# Government Working Group

## Justification for Opposing Proposed Change to MIL-STD-883 Intended Seal Width Requirement

Presented at the JEDEC JC13 Task Group 15-02 X-Ray Seal Voids Meeting

January 24, 2017

FIGURE 2076-7. Design sealing width and seal fillet graphic.

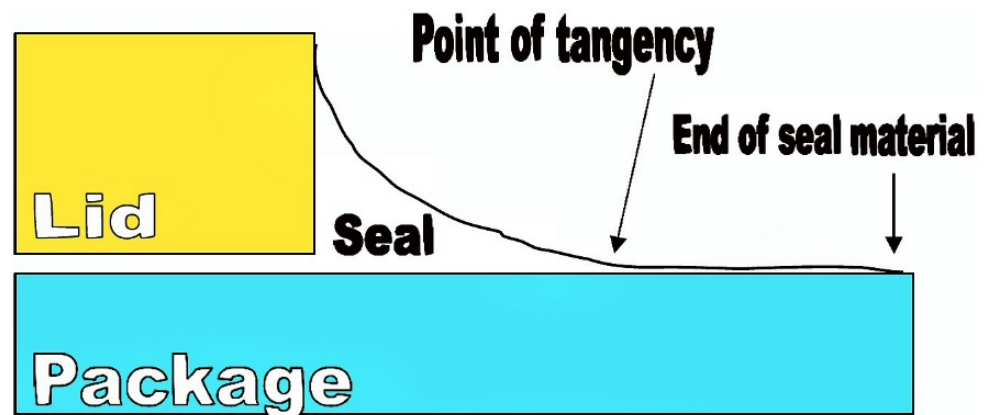
- The GWG recommends the fillet allowance stated in MIL-STD-750 TM2076 be removed.
  - Even though TM1071 leak rate limits are tighter than those given in MIL-STD-883 TM1014 (with the exception of space level hybrid microcircuits), these tests are performed on pristine product, which does not take into consideration mechanical shock/vibration/thermal stress induced during handling, installation, board/box/system level testing, and end use.

Figure illustrating voids, solder pullback, and microcrack in lid seal

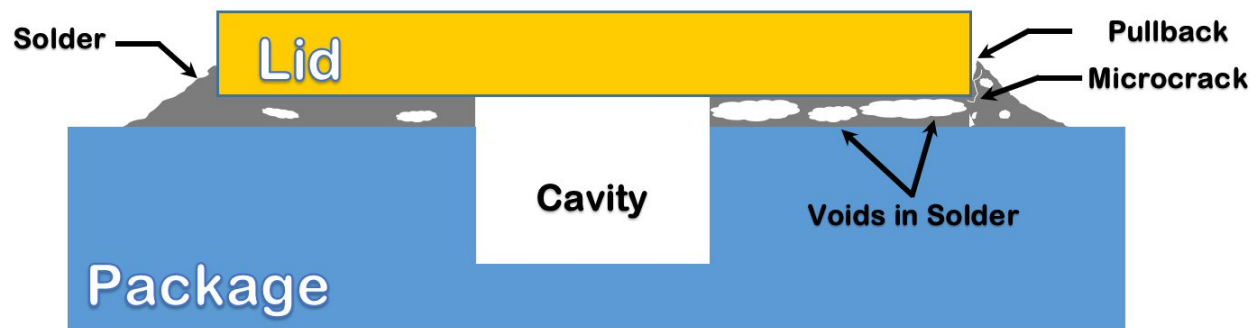
- DLA Land and Maritime has no history of why fillet was included in the seal width for MIL-STD-750 product (requirement inserted in TM2076 in 1/3/2012)
  - M750 has significantly tighter leak rates than M883 and some believe the fillet inclusion was a compromise since tighter leak rates and this change were made in the same timeframe.
- The fillet is not a design feature of the seal process.
  - Fillet width is not a controlled process.
    - Fillet forms when solder flows out from under the lid during the sealing process, and tapering of the fillet results in a non-uniform seal width (see figures on Slide 8).
    - Solder pullback severity can negate the seal effectiveness of the fillet.
    - Microcrack(s) not distinguished in x-rays may compromise seal integrity as they can propagate to a void area when part is placed on board or during box level and system level testing.

## • Example 1: Excessive Voiding Underneath Lid

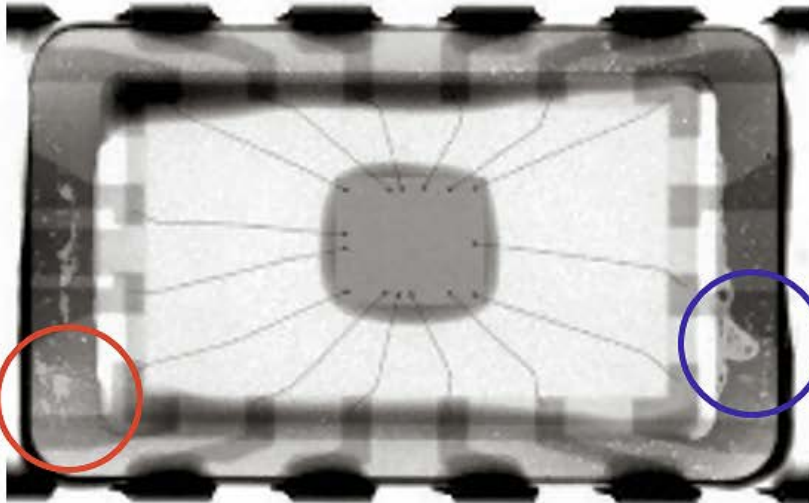
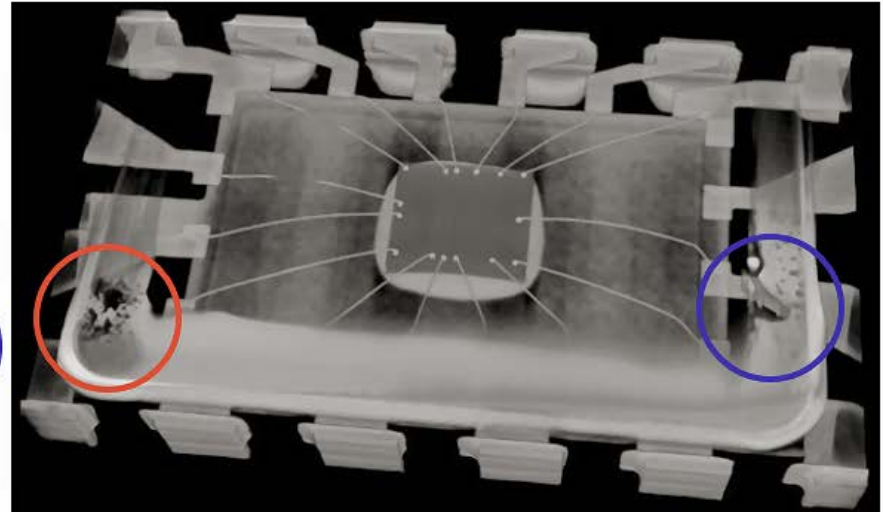
- Voids may reduce sealing width underneath the lid by more than 75% and also contact the fillet.
  - Microcrack(s), not distinguished in x-ray, may compromise seal integrity as they can propagate to a void area.
- The current lid seal requirements would fail this device, yet pass if the fillet is included in the intended seal width.

This part was a randomly selected sample and had this void issue. Because this part was randomly selected, it is highly probable that there are other parts with similar issues.

- **Example 1: Excessive Voiding Underneath Lid (continued)**
  - The current lid seal requirements would fail this device, yet it would pass if the fillet is included in the intended seal width.

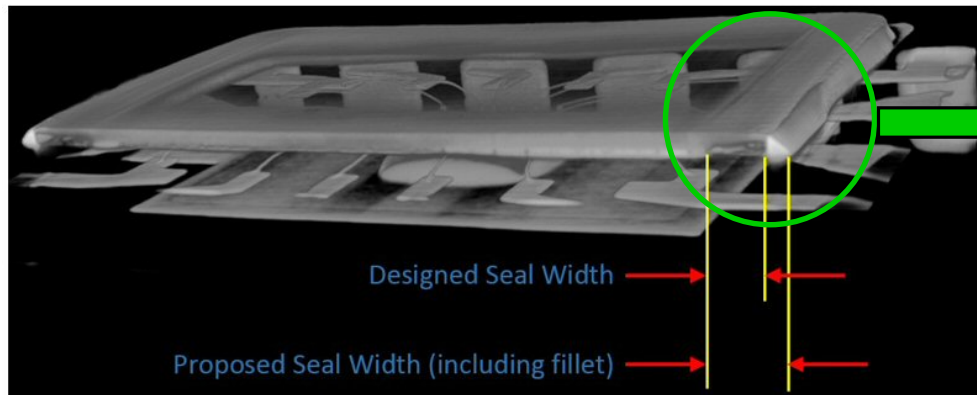
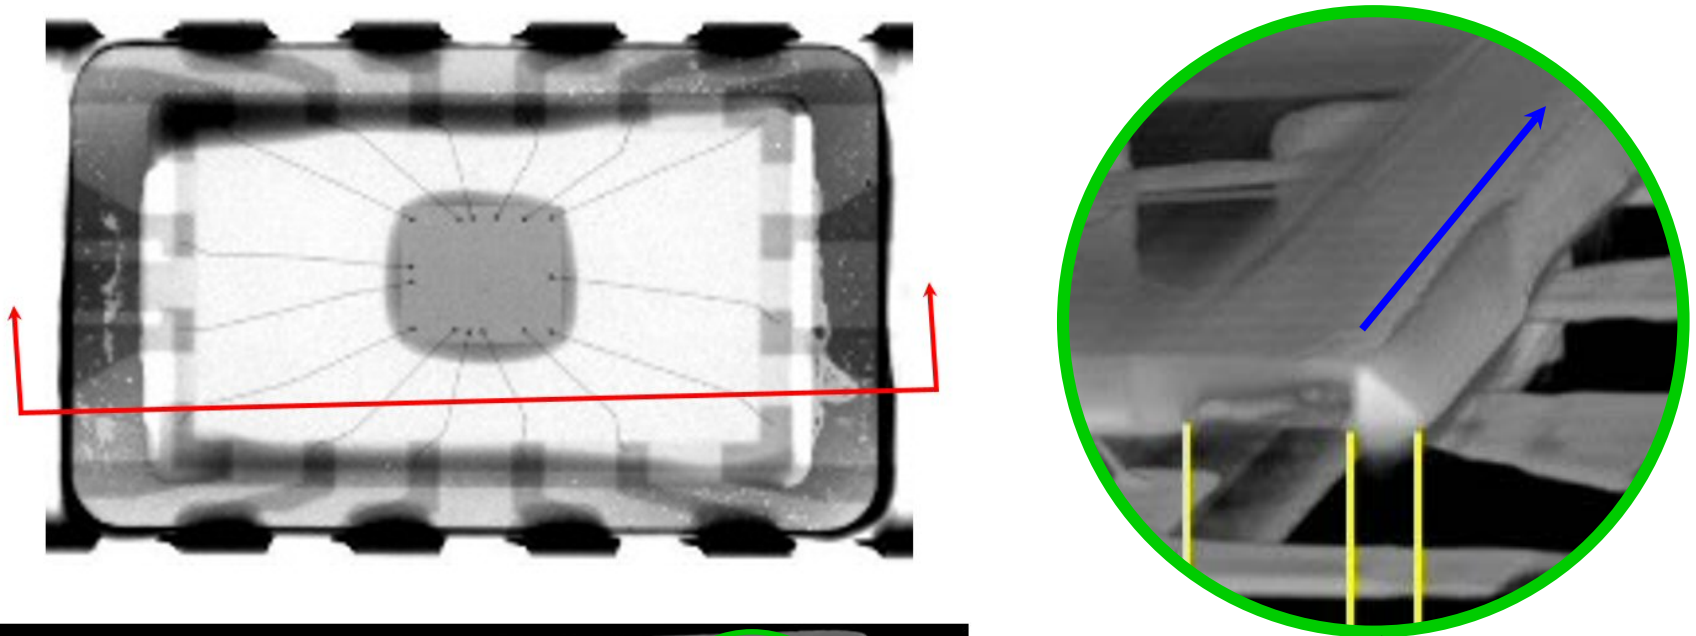
Darkened areas in the designed seal width are voids and the fillet width tapers (blue arrow).

## • Example 2: Excessive Voiding Underneath Lid

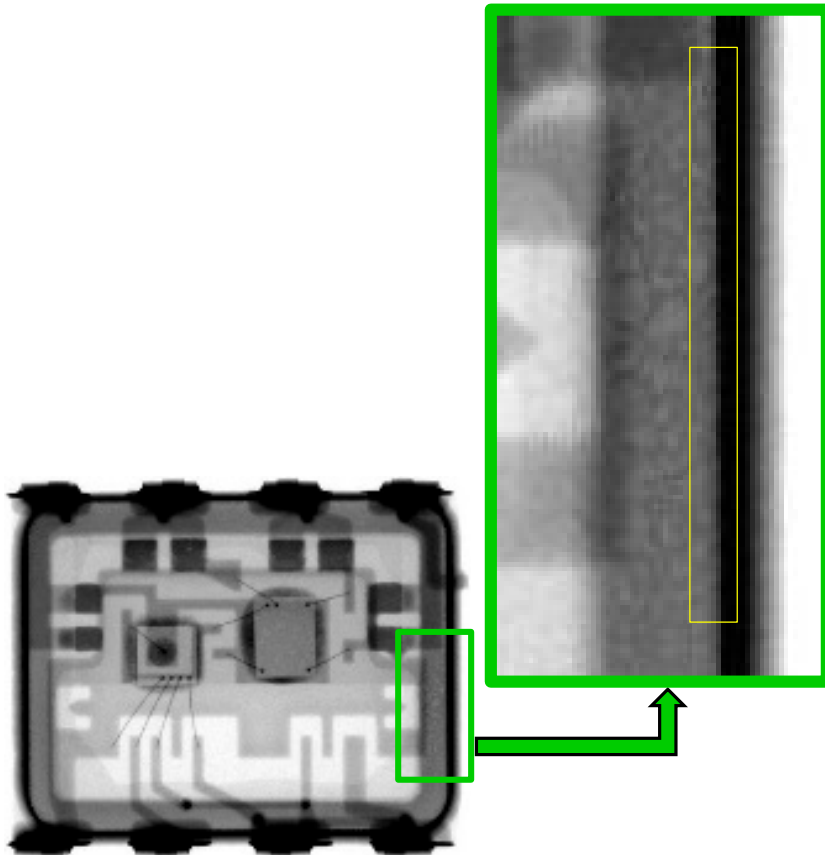
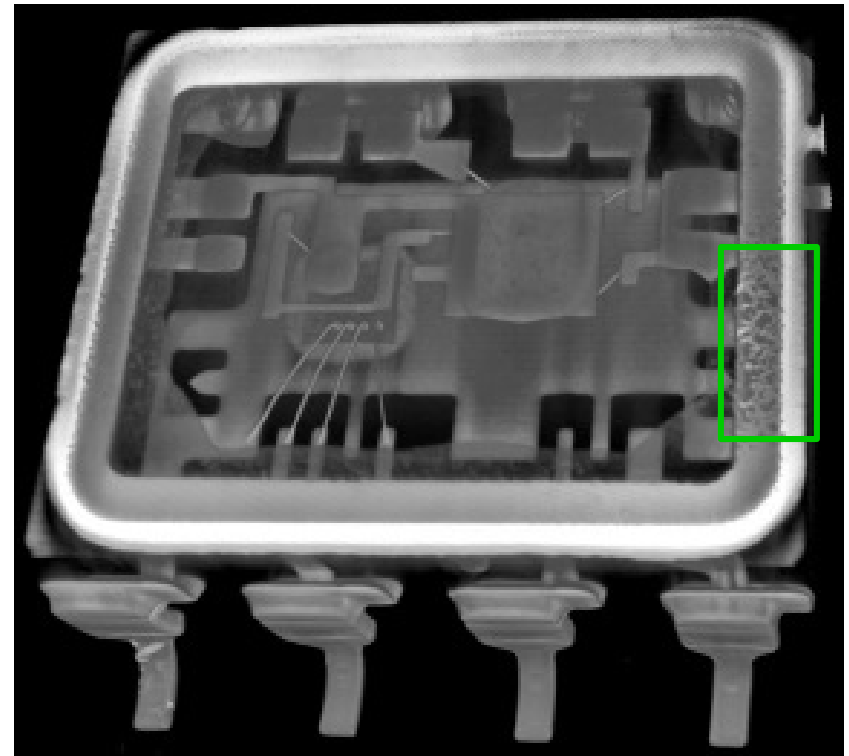
- Voids reduce sealing width underneath the lid by more than 75% and pinholes exist in fillet area next to the lid. Note that the pinholes are not clearly detected in the 2D x-ray image (yellow box) due to the thick, x-ray dense solder of the fillet.

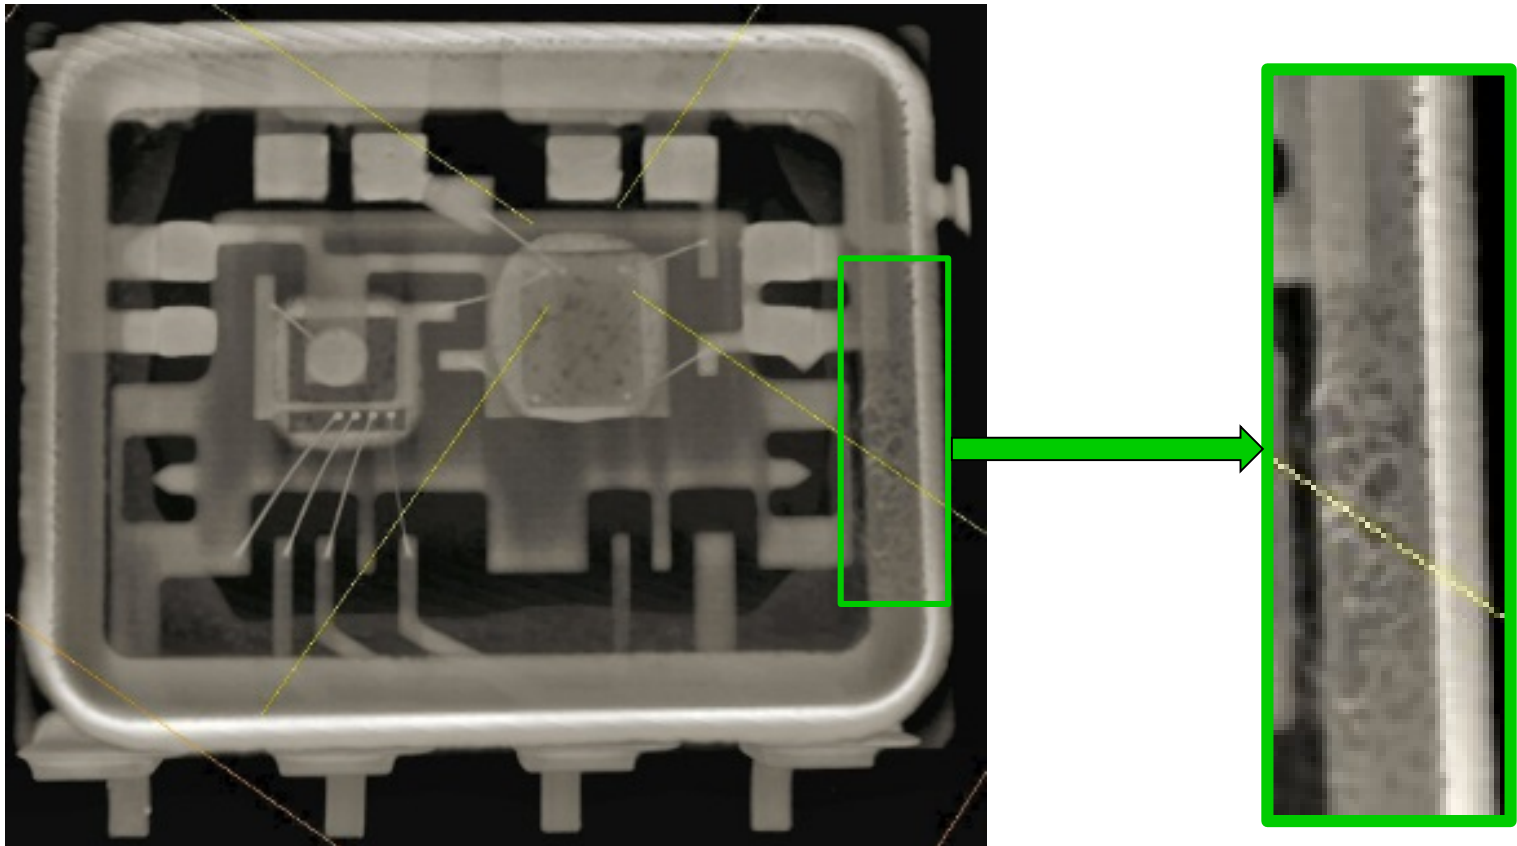
- **Example 2: Excessive Voiding Underneath Lid (continued)**
  - Another 3D-CT image of the device shown on Slide 9. This part would fail the current criteria, but would pass if the fillet was included in the design width. Note the pinholes in the fillet next to the edge of the lid, which provides a potential leak path.
